Technical Service Bulletin: TSB160094	Released Date: 09-Sep-2016	
Circular Tube Exhaust Gas Recirculation (EGR) Cooler

Circular Tube Exhaust Gas Recirculation (EGR) Cooler

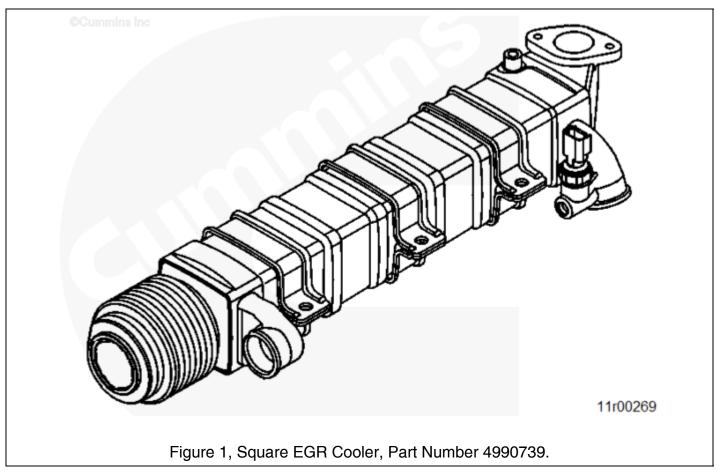
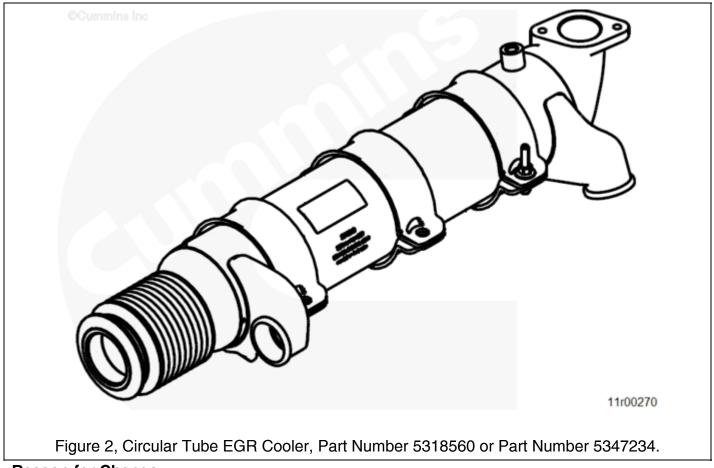
- This document announces the release of a circular cross-section exhaust gas recirculation (EGR) cooler which contains internal circular tubes.
- The circular tube EGR cooler replaces the existing square EGR cooler which contains horizontal plates.
- See Figures 1 and 2 below for examples of each EGR cooler design.
- An EGR cooler submerged pressure test has been developed and is now a required diagnostic step prior to replacement of the EGR cooler. Refer to Procedure 011-019 (/qs3/pubsys2/xml/en/procedures/45/45-011-019-tr-islg.html) in Section 11.

• The circular tube EGR cooler is a more robust EGR cooler design.

- The horizontal plate EGR cooler has a square cross-section with flat internal plates.
- The circular tube EGR cooler has a circular cross-section with circular internal tubes.

- The new circular tube EGR cooler, Part Number 5347234 (kit part number 4376312), **must** be used for all EGR cooler replacements.
- Updating to the new circular tube EGR cooler requires an installation kit. See Table 1 below for the installation kit Part Number. The installation kit contains the coolant vent line required for installation of the new circular tube EGR cooler.
